l. Type of Well ☑ Oil Well ☐ Gas Well ☐ O	ther			8. Well Name and No. STAMPEDE FEDERAL WC COM 34 1H		
Name of Operator CONOCOPHILLIPS COMPA	Contact:	KRISTINA MICKENS ckens@conocophillips.com		9. API Well No. 30-015-42123-00-X1		
3a. Address MIDLAND, TX 79710 1810 4. Location of Well (Footage, Sec	T. D. M. C. D. William	3b. Phone No. (include area code Ph: 281-206-5282	e)	10. Field and Pool, or Exploratory WHEDCAT WC-015 G-08 52631		
Sec 34 T26S R31E Lot 4 029 32.000270 N Lat, 103.46222	50FSL 0380FWL		-	EDDY COUNTY, NM

Sundry Notice Request ConocoPhillips Company WILDCAT Stampede Federal WC COM 34 1H

ConocoPhillips Company respectfully requests to amend the approved permit to drill. It is our intent to utilize the proposed 10M BOPE system to drill out of the surface casing, and test in a manner necessary for well control and suitable with pressure ratings of the multi-bowl wellhead system (attached).

PECOS DISTRICT CONDITIONS OF APPROVAL

20" x 13-3/8" x 9-5/8" x 7-5/8" x 5" 10/15M SH2/Conventional Wellhead Assembly

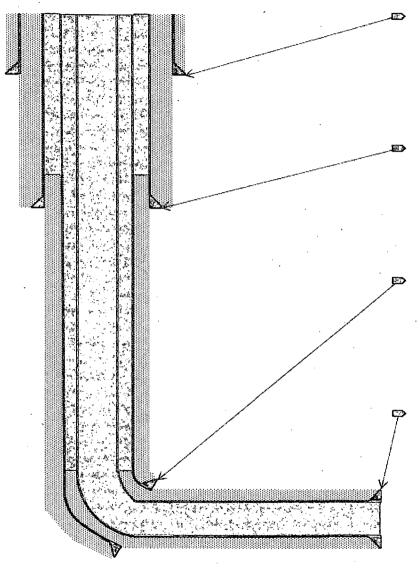
The testing procedures for prior to drill out of the surface casing (12-1/4" hole size) shall still apply to the approved working pressures of a 5M system, and not the upgraded higher working pressures. The reason is that the maximum anticipated surface pressures for the 12-1/4" hole section is less than 1,500 psi (0.46 psi/ft pressure gradient assuming fully evacuated). ConocoPhillips intends to test as indicated in the Onshore Order 2 for 5M rated BOPE with a test plug to 5,000 psi for all and 3,500 psi (70%) for the annular type preventer.

In the 8-3/4" hole section, the maximum anticipated surface pressure remains to be less than 2,500 psi (0.30 psi/ft pressure gradient assuming partial evacuated). Therefore, ConocoPhillips chooses to continue drilling the 8-3/4" hole section without retest (less than 21 days) as which the previously test 5M system would still apply to the approved working pressure.

Prior to drilling out the 7-5/8" intermediate casing (6-5/8" hole size), ConocoPhillips shall test to the rated working pressure of a full 10M BOPE system as it is subjected to the maximum anticipated surface pressure of 6,500 psi (0.655 psi/ft pressure gradient assuming fully evacuated) per Onshore Order 2. The full pressure test shall be performed with a 10M rated test plug after installing the 7-5/8" 10M wellhead packoff assembly prior to drilling out the 7-5/8" intermediate casing (6-5/8" hole size). Please see the following attached schematics.

- 3. Operator has proposed a multi-bowl wellhead assembly. This assembly will only be tested when installed on the surface casing. Minimum working pressure of the blowout preventer (BOP) and related equipment (BOPE) required for drilling below the surface casing shoe shall be 5000 (5M) psi. 5M system requires an HCR valve, remote kill line and annular to match. The remote kill line is to be installed prior to testing the system and tested to stack pressure.

- 4. Minimum working pressure of the blowout preventer (BOP) and related equipment (BOPE) required for drilling below the 7-5/8" casing shoe shall be 10,000 (10M) psi. 10M system requires an HCR valve, remote kill line and annular to match. The remote kill line is to be installed prior to testing the system and tested to stack pressure.
